8.7 Summary of amendments following meeting with Richmond Council

Project number	A2871
Project title	Greggs Bakery, Twickenham
Document title	Design and Access Statement
Client	London Square
Document status	Planning Submission
Date of issue	14 December 2022
Prepared by	Chloe Simons, Architectural Assistant
Checked by	Ed Sharland, Associate Director

Planning submitted landscape proposal Proposed revision

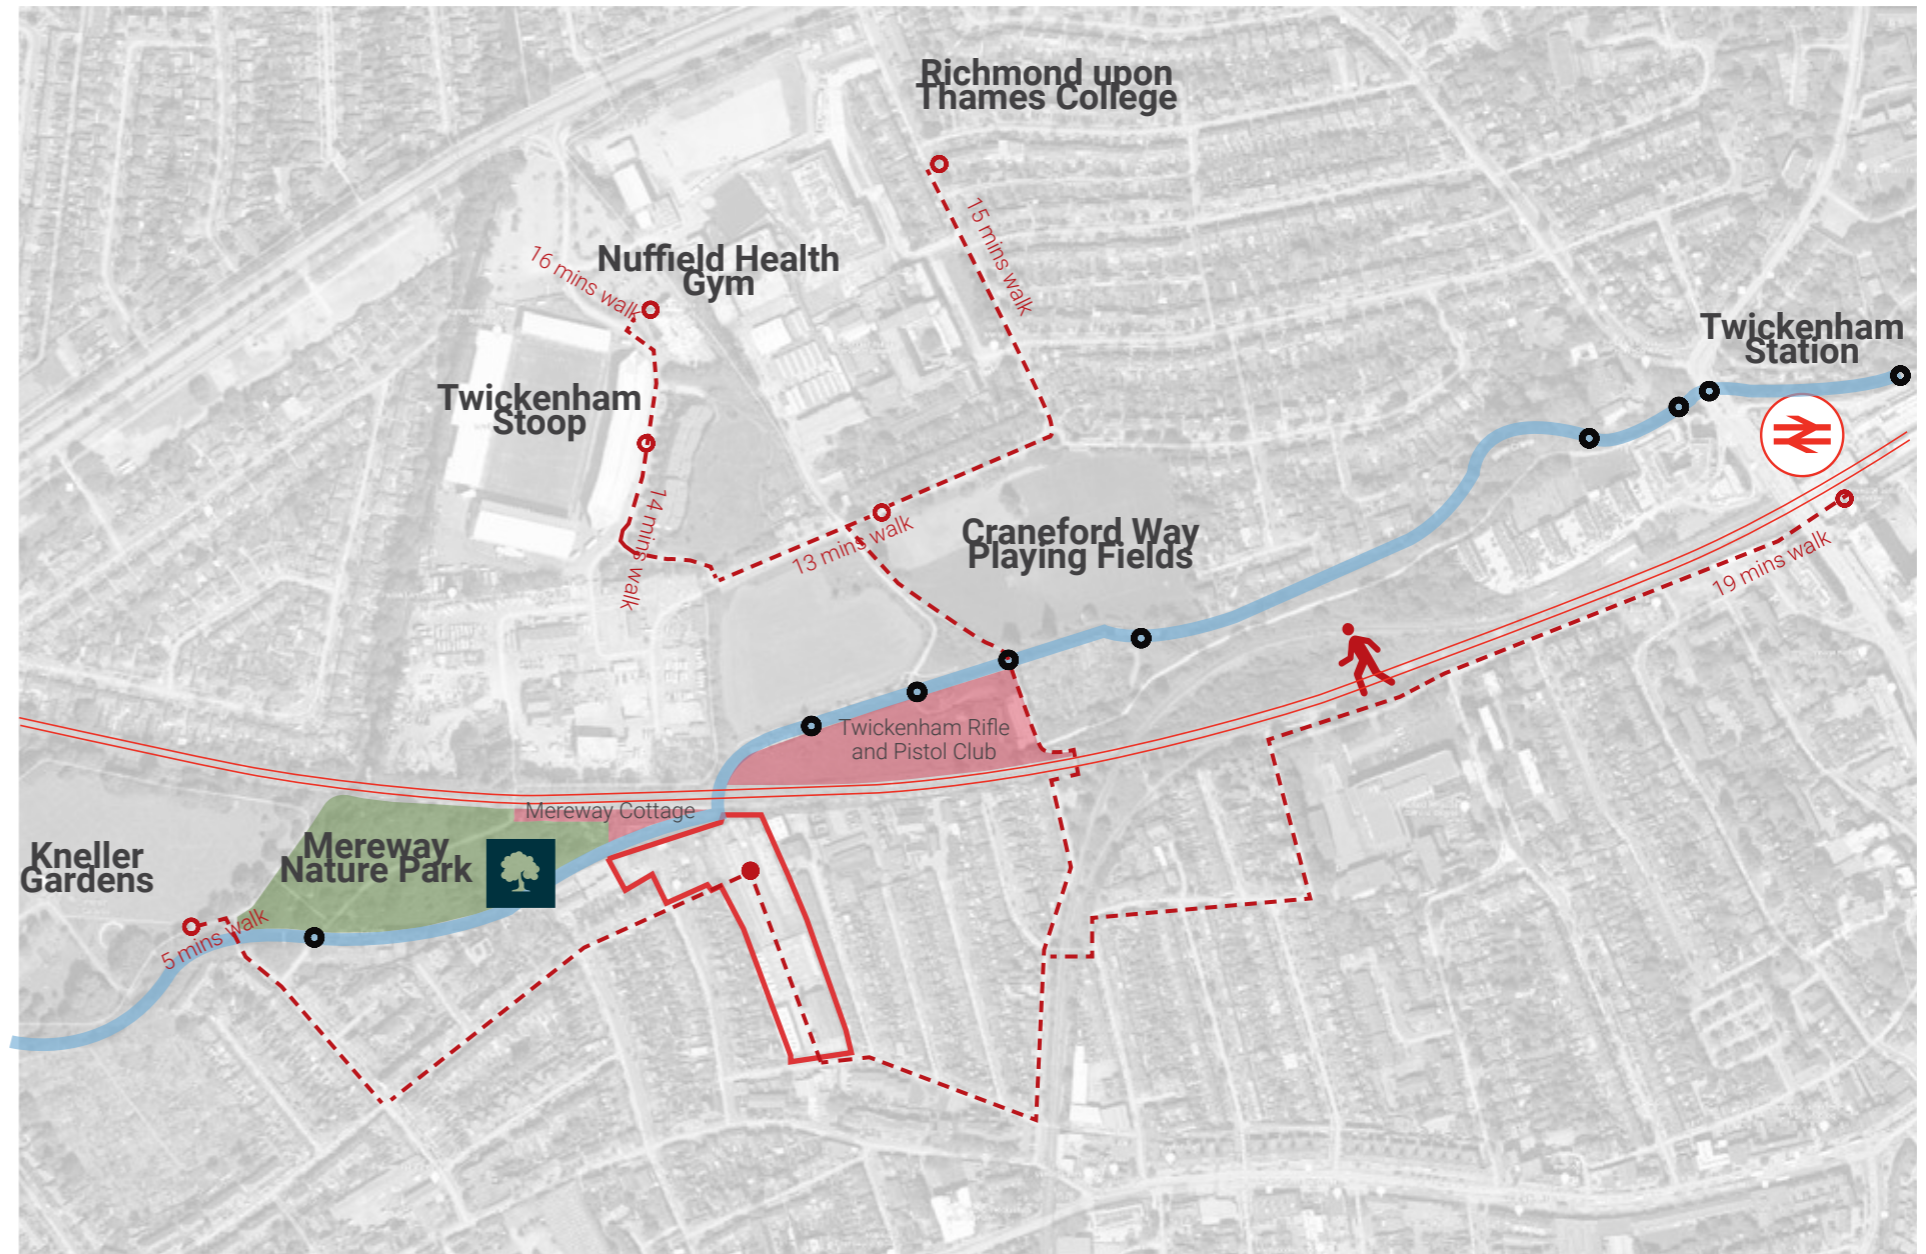
Riverwalk
 Planning objections were raised with regards to the impact of the proposal on wildlife along the River Crane and the amount of likely illumination the development would cause to the 'Dark Corridor' of the river.

Further changes to the landscape and lighting design along the riverfront restrict the amount of light-spill reaching the sensitive area so as to have the absolute minimum impact on wildlife. The lighting will be designed in line with the Exterior Lighting Assessment by Desco.

The introduction of a 5m buffer zone heavily planted with native and wildlife friendly planting, natural pathway and play elements; a 1.2m wide pathway will consist of self binding gravel (Breedon / Hoggin or similar acceptable materials); and a 1.5m high hedge with 600mm tall woven willow trellis to the southern face which will prevent light-spill onto the river.

All vehicular routes, building footprints and hard-landscaping are outside of the 5m buffer zone.

Option 1 - Bridge location over the river and railway

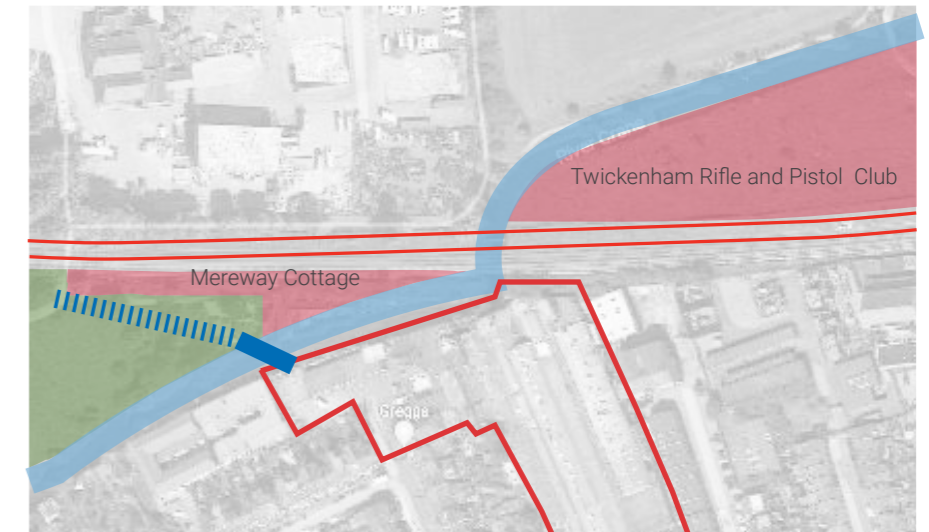
In response to comments made at the public consultation we have looked at the possibility of facilitating a new pedestrian crossing over the River Crane as part of the design process.

Option 1 would require a bridge to go over both the railway line and river. This would require the bridge to go up a significant height and traverse a long distance. It would also need to be approved by Network Rail.

Option 2 requires a diagonal span to the Mereway Nature Park. This is dependent on ground conditions to the west and is likely to have a negative effect on the biodiversity of the nature park.

It is considered option 2 is the only feasible option for a future bridge.
